STATE OF IDAHO
DEPARTMENT OF WATER RESOURCES
ADJUDICATION SECTION
CLAIM VERIFICATION FIELD EXAM SHEET
(Use with the ECVR)

CLAIM NO(s). 75-4089

75-4089

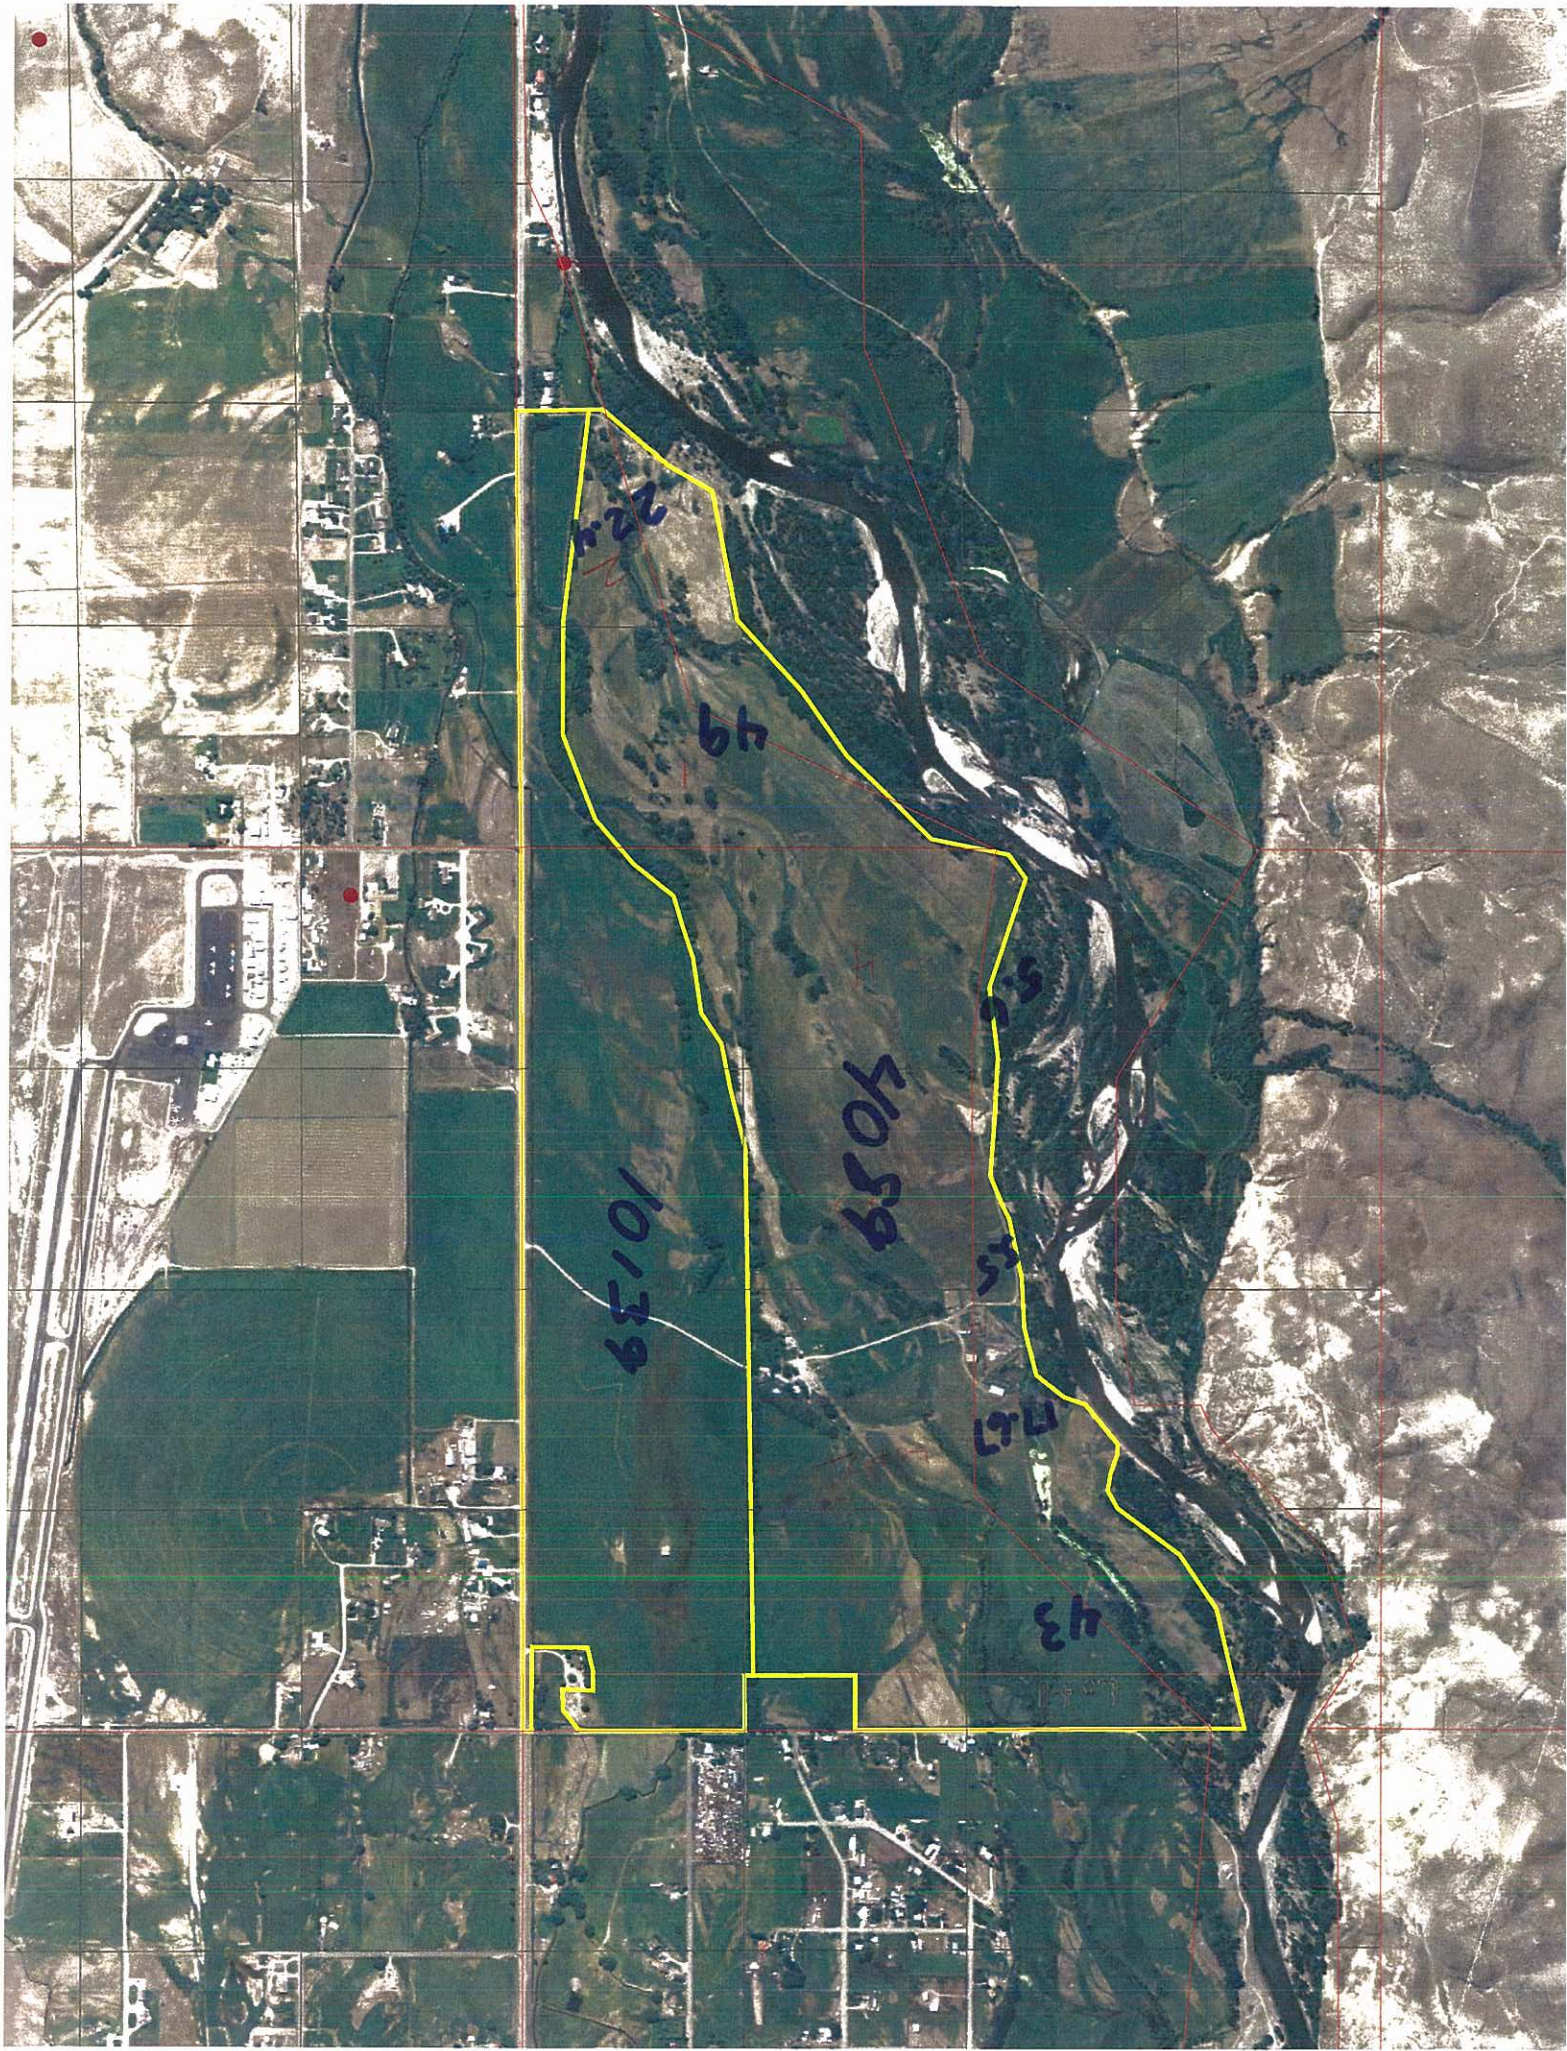
☒ Point of diversion is different than the claim and/or new P/D's:

GPS Site Tag No.: A0015026 (S-14) A0017447 (S-12)
